# ALLENDALE CHARTER TOWNSHIP PLANNING COMMISSION MEETING

We have received and reviewed the plan submittal for the proposed Allendale Christian School Expansion. The following sheets were received and reviewed, all dated April 22<sup>nd</sup>, 2021:

> Re: Site Plan and Special Use Review for Allendale Christian School Expansion 11050 64th Avenue, Allendale, MI

#### SPECIAL USE AND SITE PLAN REVIEW ALLENDALE CHRISTIAN SCHOOL DATE: May 11, 2021 PAGE 1 of 11

19-12-012 Sheet Title SITE LAYOUT

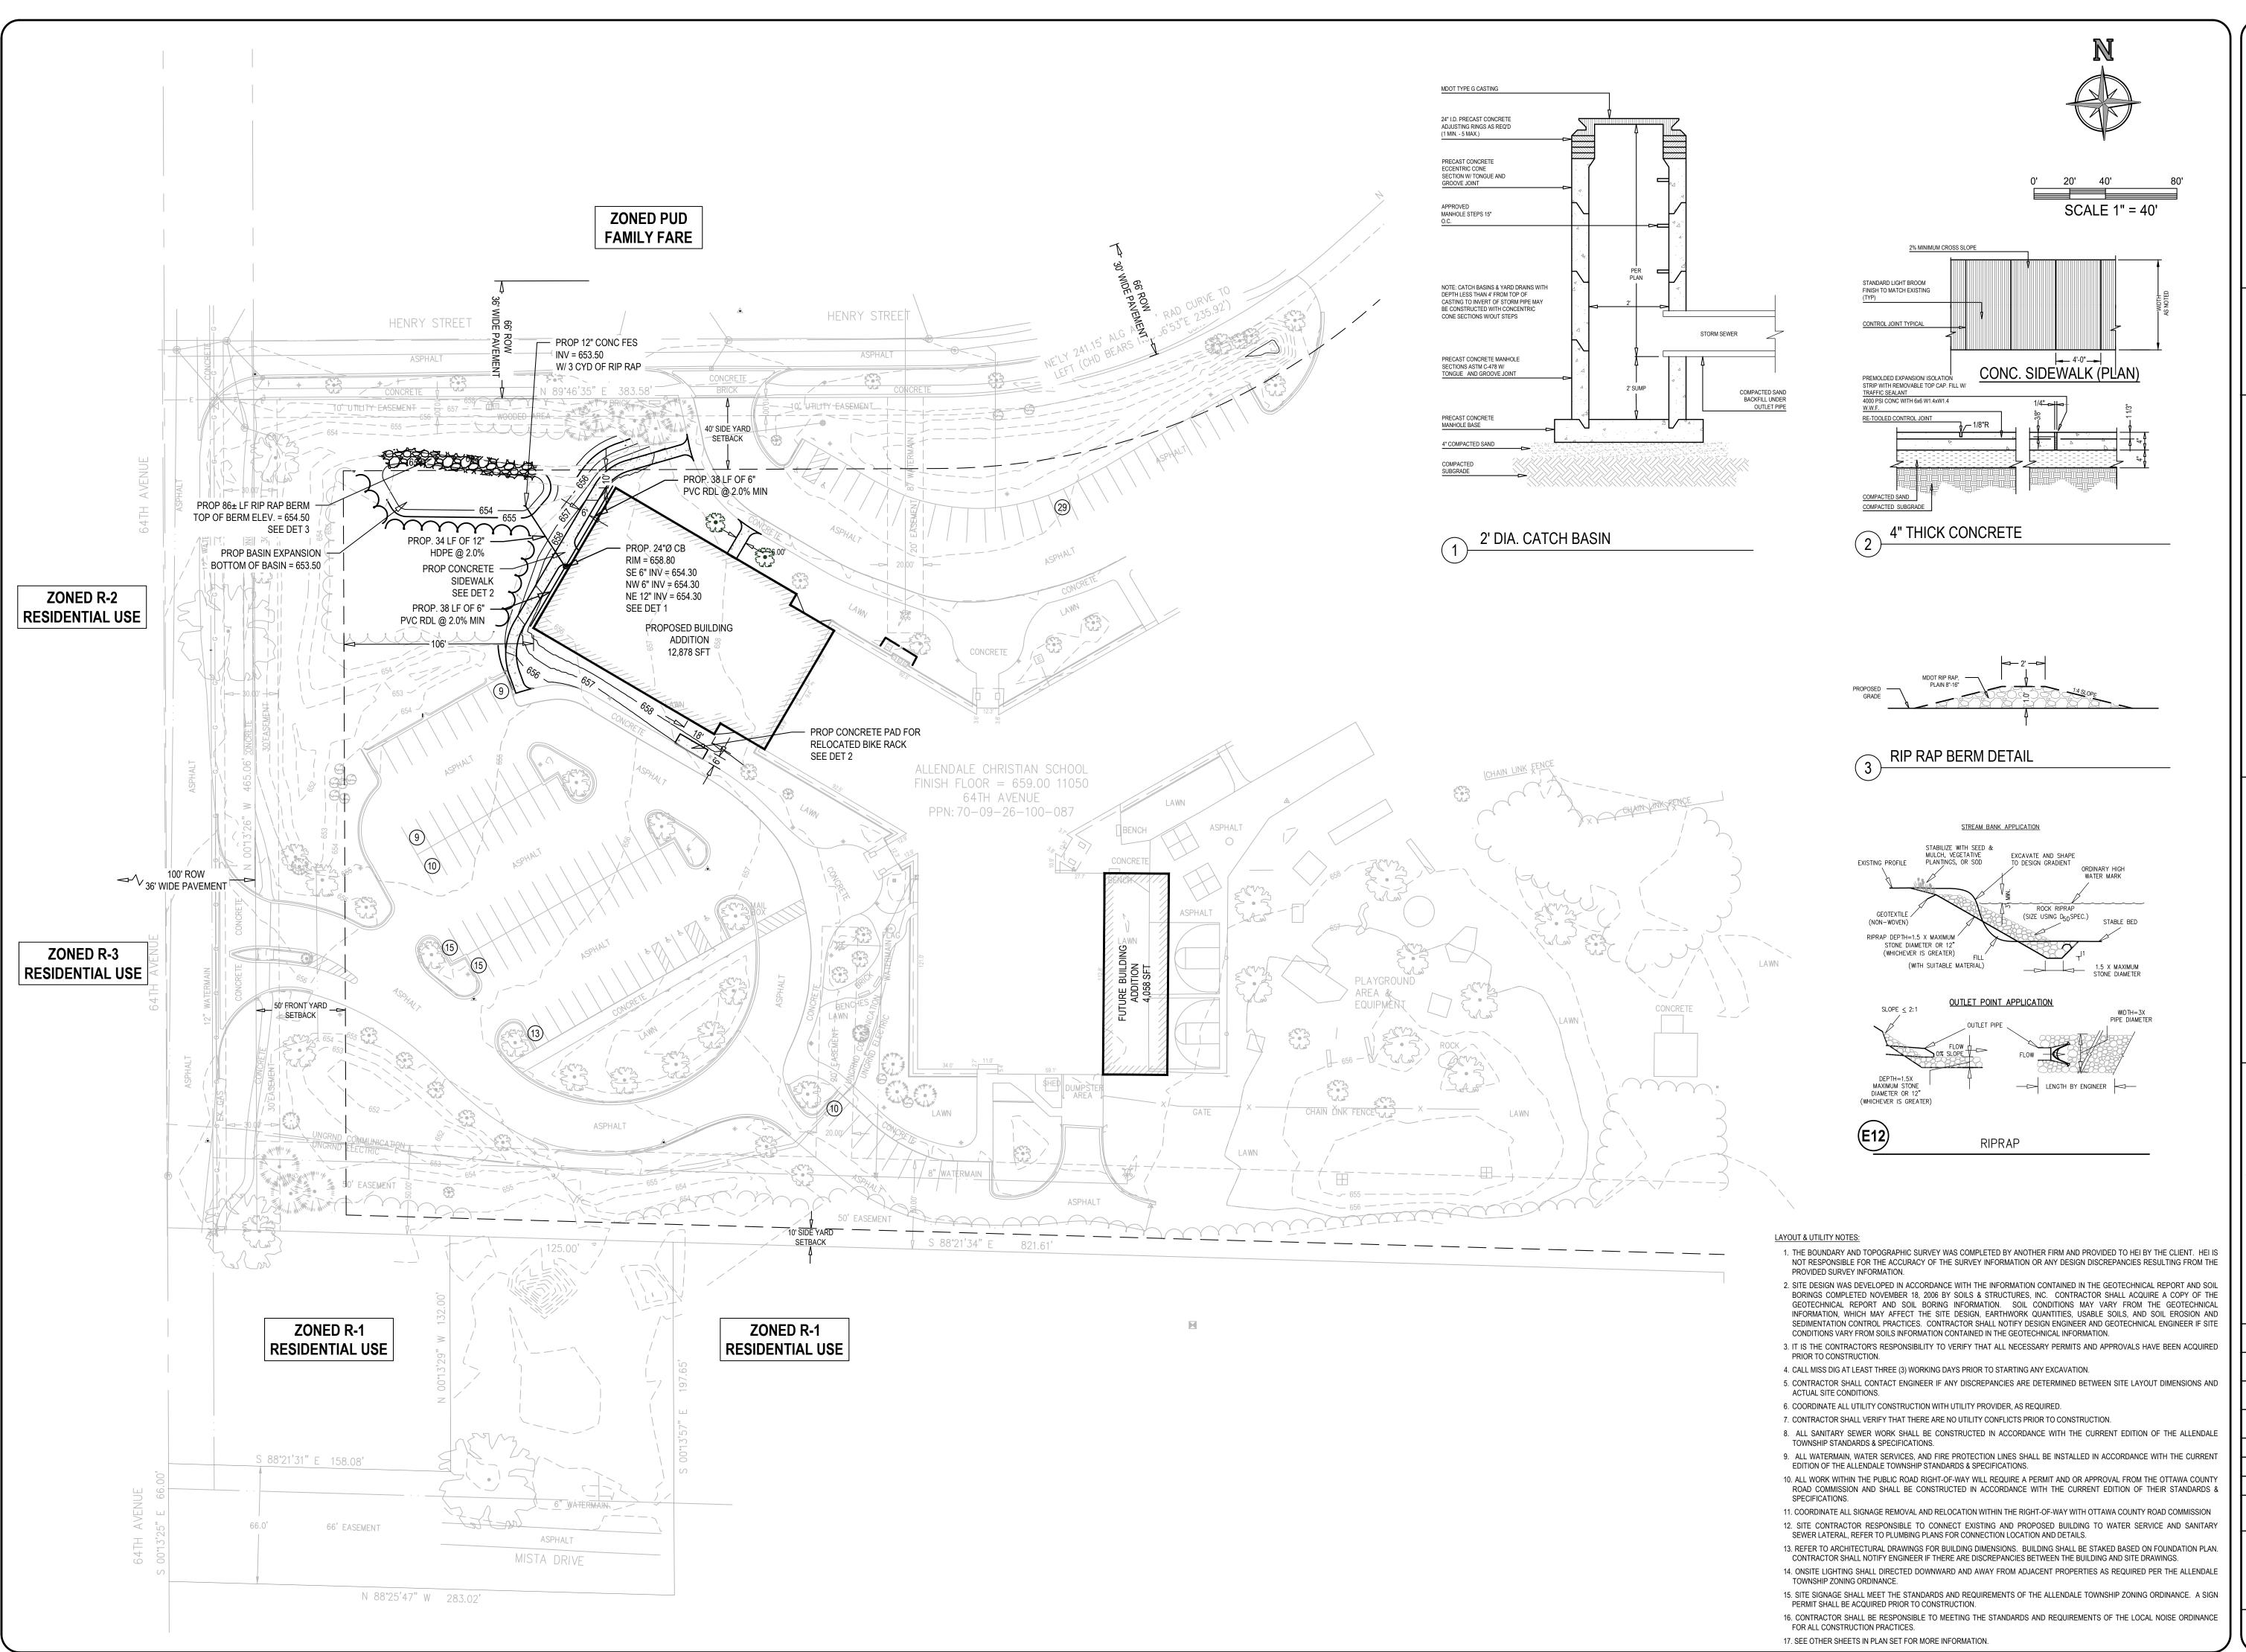
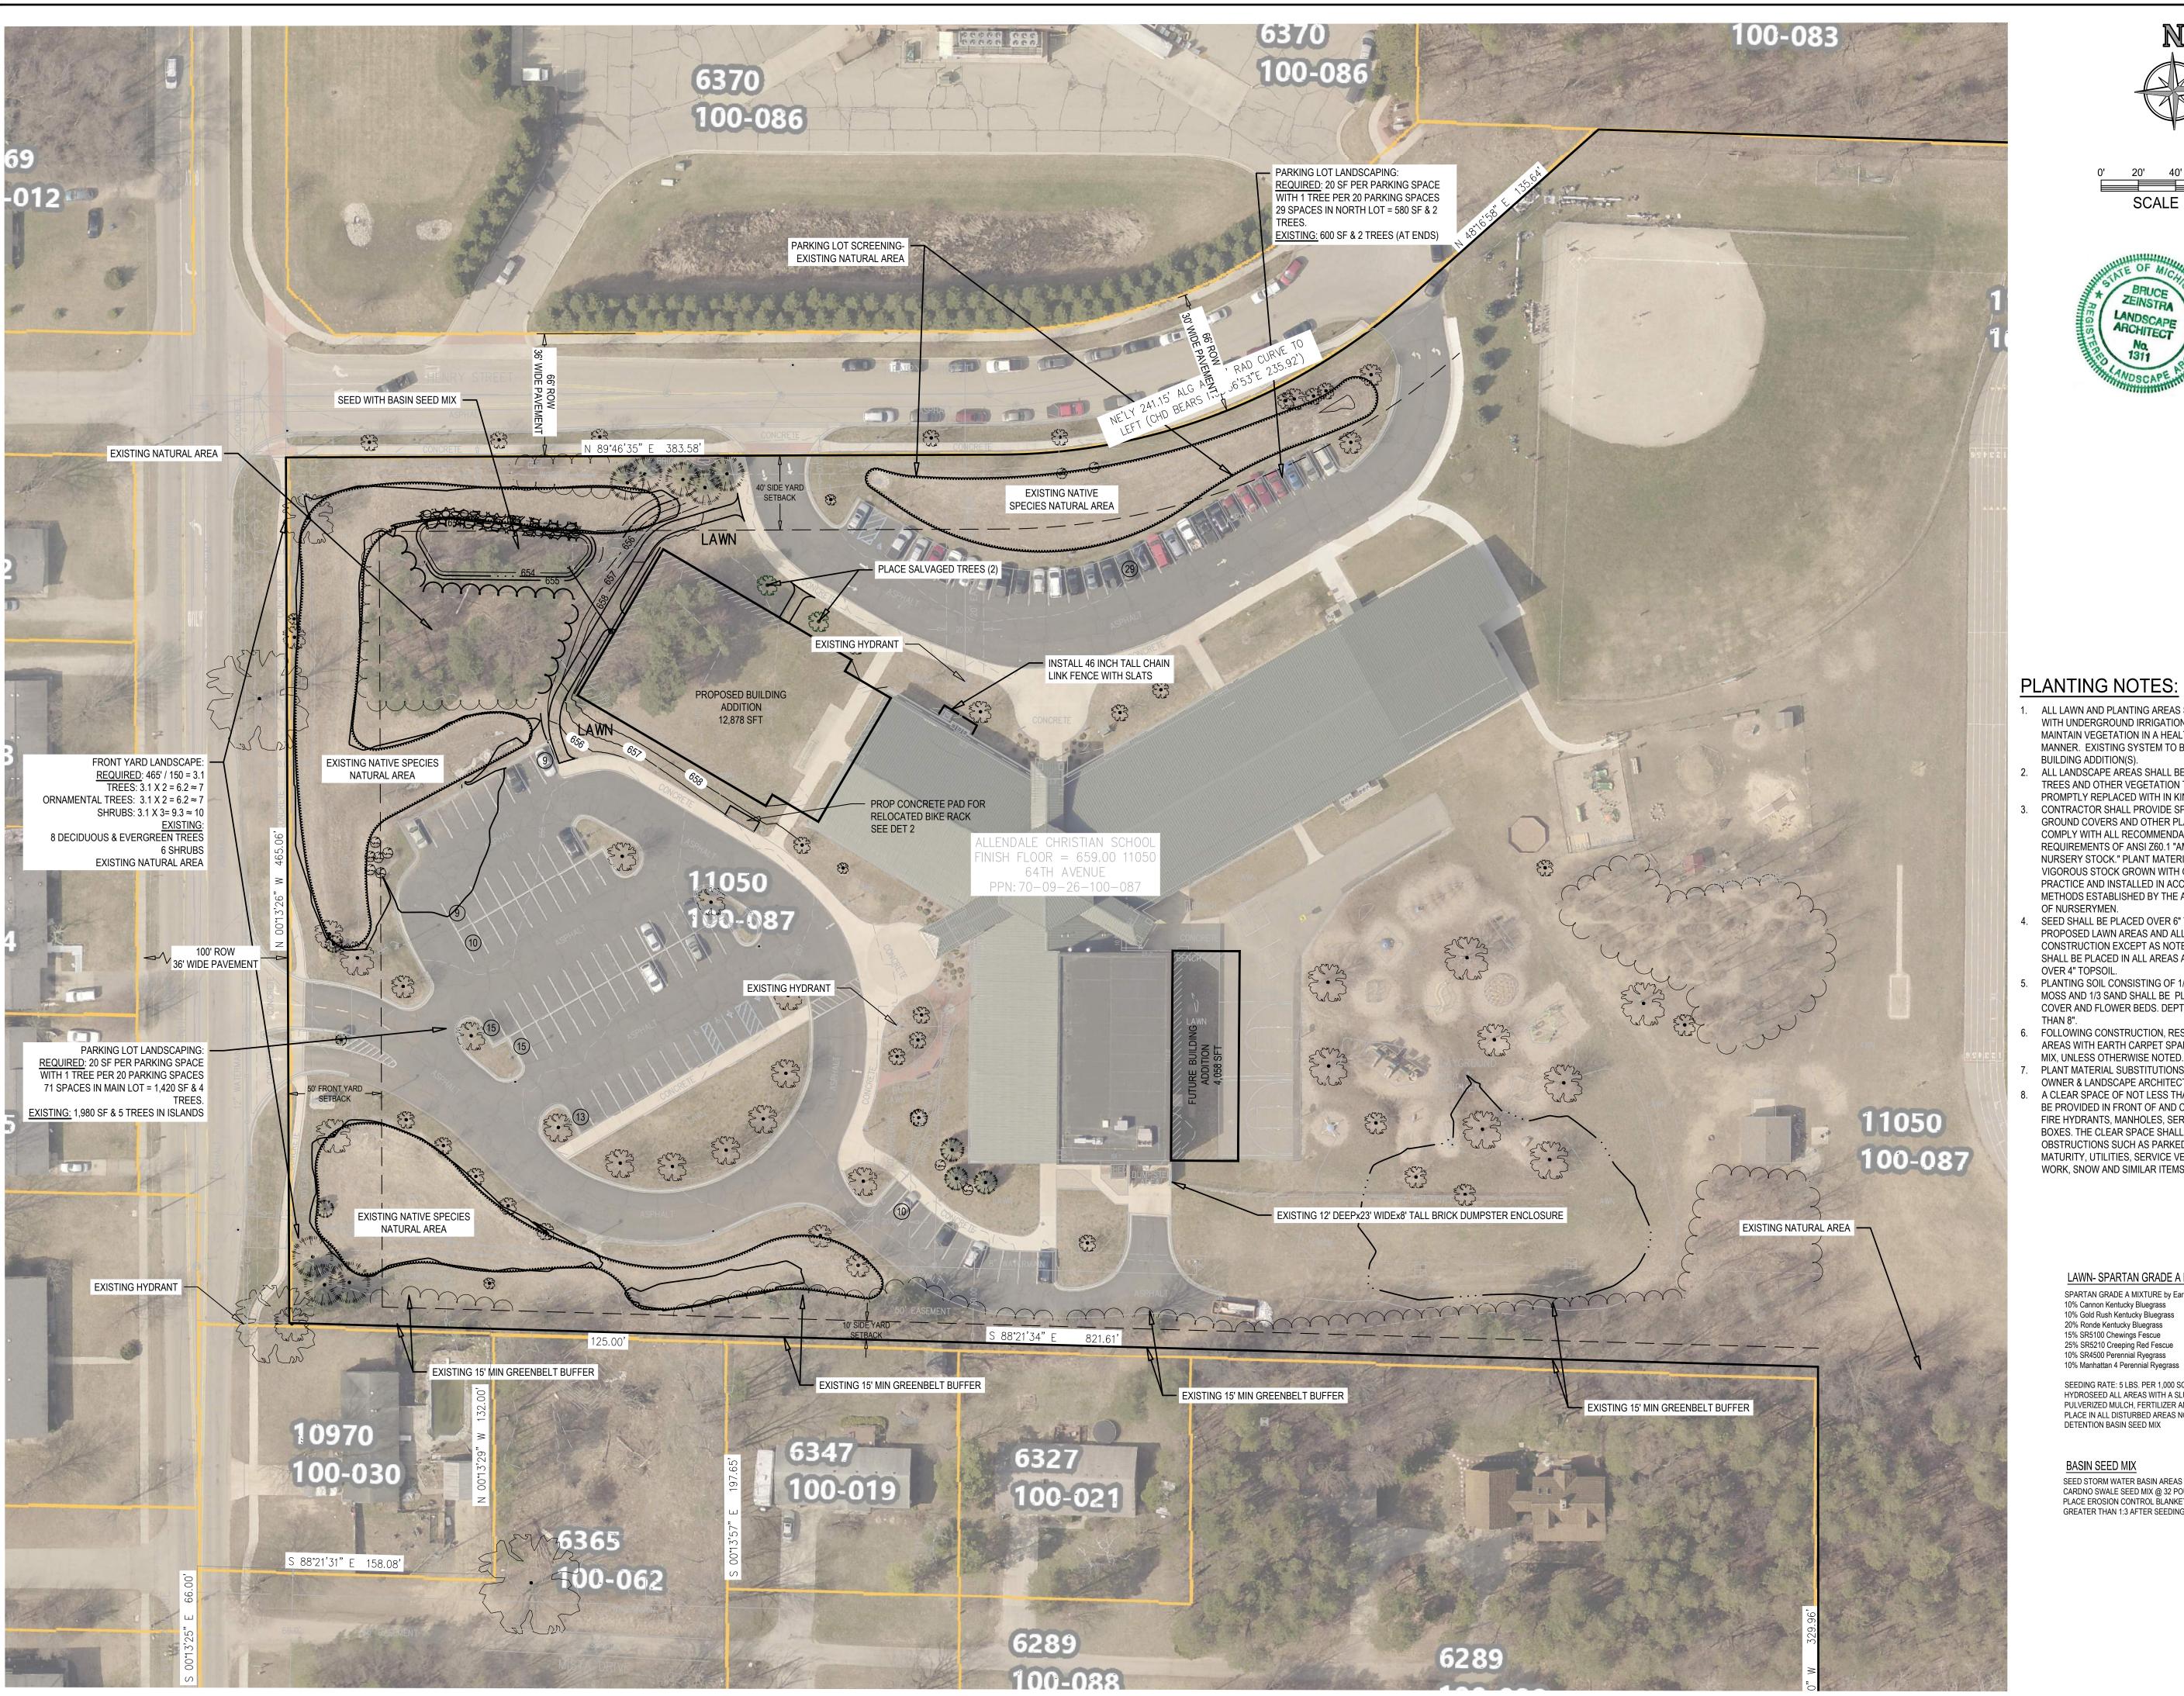
Sheet C - 100:

Sheet C - 101:

• Sheet C-101 – Surrounding zoning has been removed from the previous submission. Even though Sheet C-100 has a Zoning Map, some zoning districts are missing from adjacent parcels. Please revise accordingly.

**Response:** Additional zoning information has been added on sheets C-100 and C-101 for reference.

**Response:** Additional information has been added on Sheet C-100 to show the lot lines and dimensions for the entire site.

**Response:** Additional information has been added on Sheet C-100 to show the specific uses and zoning on property's adjacent to the site.

**Response:** Additional information has been added on Sheet C-100 to show the lot lines and dimensions for the entire site, with specific setbacks noted in the area of improvements.
